**From:** Lasley, Timothy G  
**Sent:** Wednesday, May 23, 2018 11:46 AM  
**To:** 'jenniferfeist@murray-enterprises.com'  
**Cc:** Werner, Jeffrey B; Mess, Camie  
**Subject:** BAR Actions - May 15, 2018 - 815 East High Street

BAR 18-05-05

815 East High Street

Tarleton Oak, LLC, Owner/ Jennifer Feist, Applicant  
Site Elements and Design

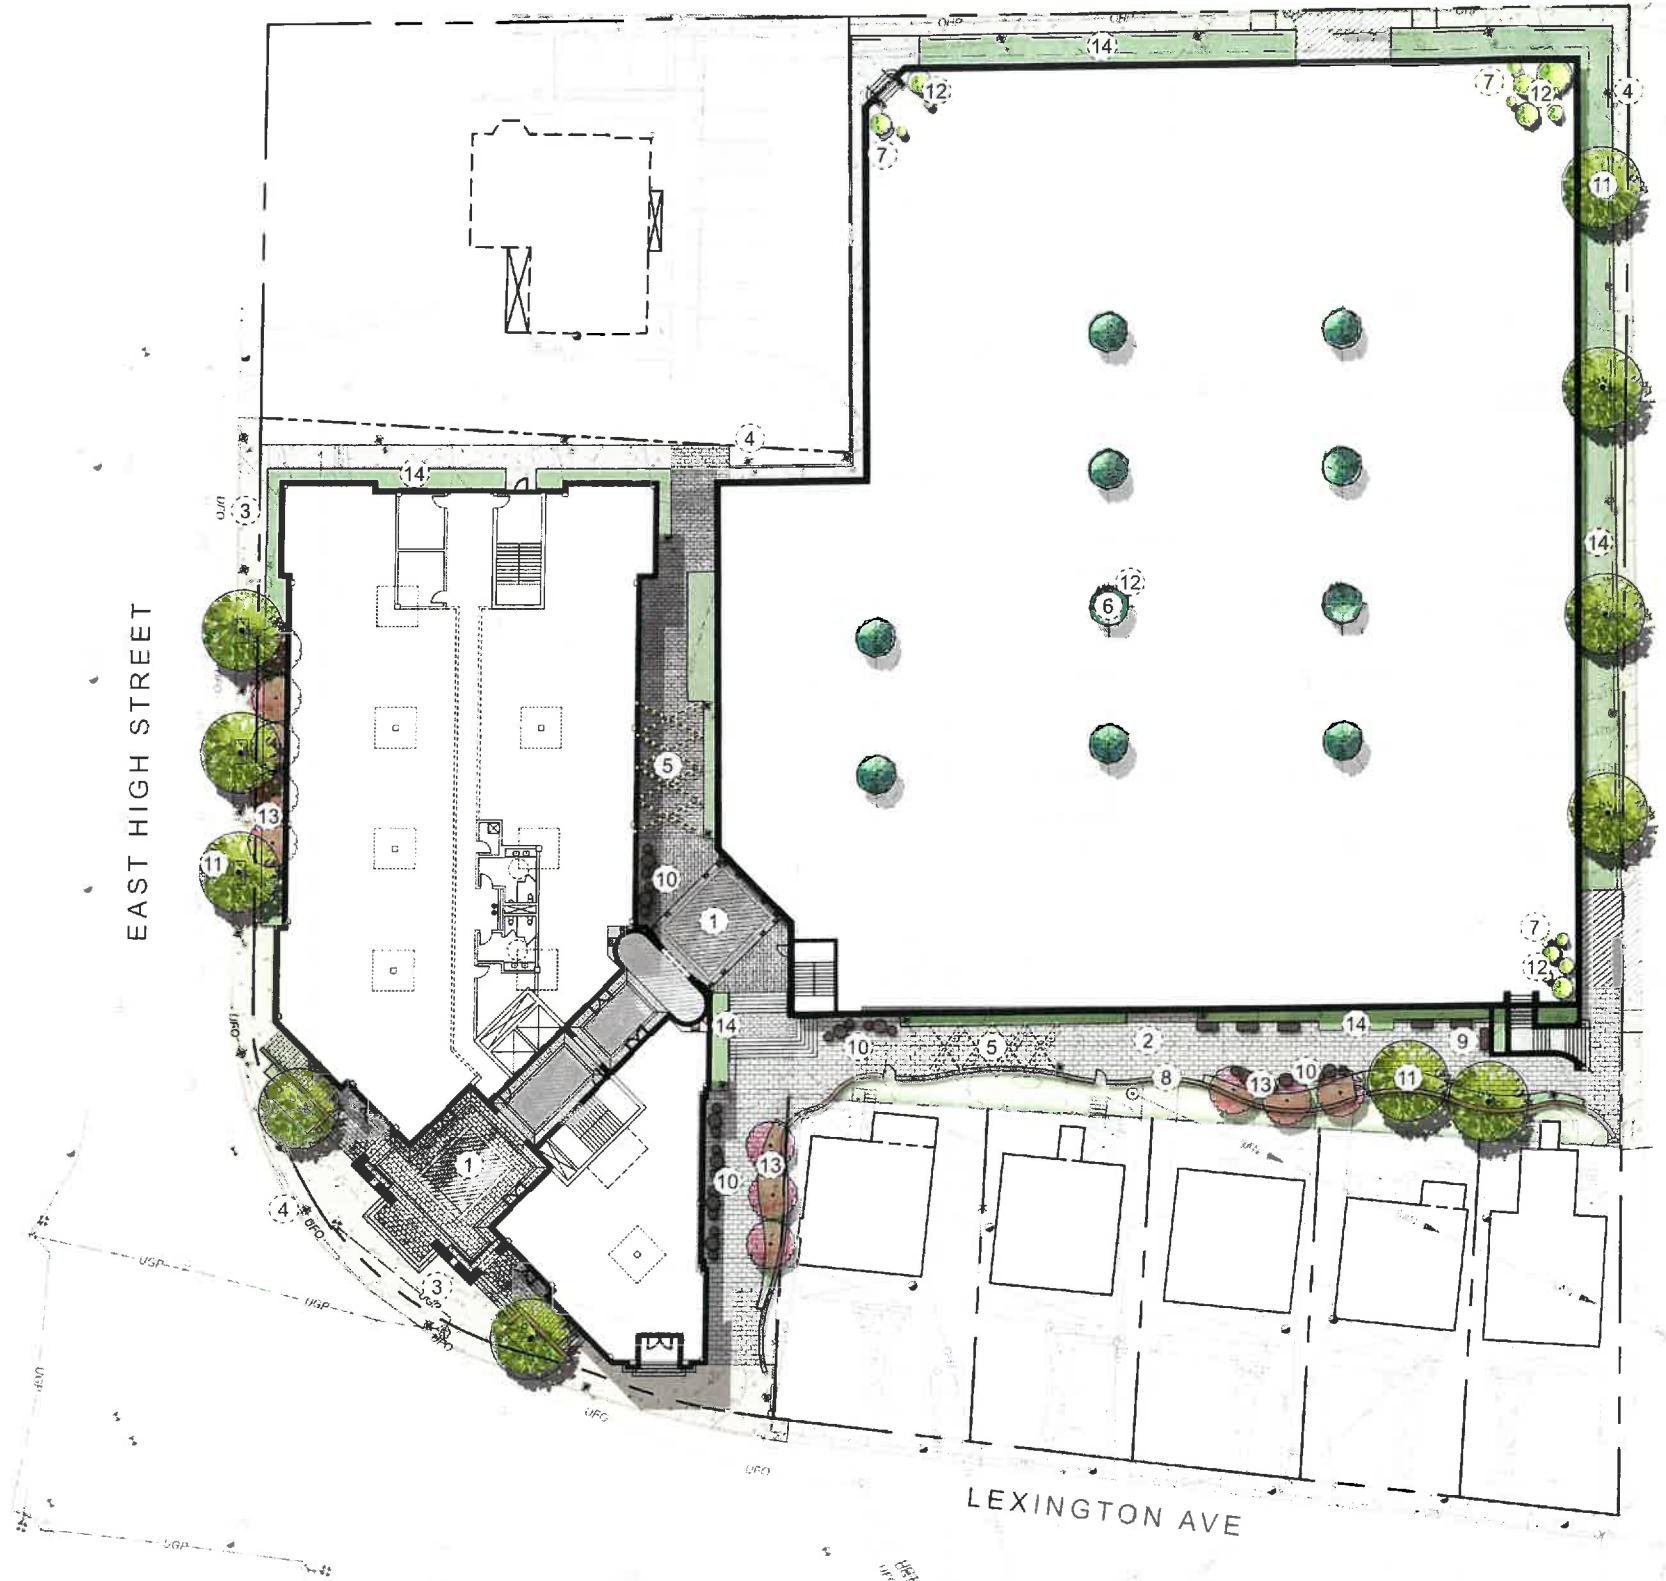
**Motion: Schwarz moved having considered the standards set forth within the City Code, including City Design Guidelines for New Construction and Additions, I move to find that the proposed landscape plan satisfies the BAR's criteria and is compatible with this properties and other properties in the Martha Jefferson Historic Conservation District, and that the BAR approves the proposal for Phase 1 with the following recommendations:**

- **Increase number of street trees along Maple Street and 8<sup>th</sup> Street**
- **Soften the transition between the project and 801 East High Street, a city-designated IPP.**
- **Consider use of trees from the *Tarleton Oak*.**
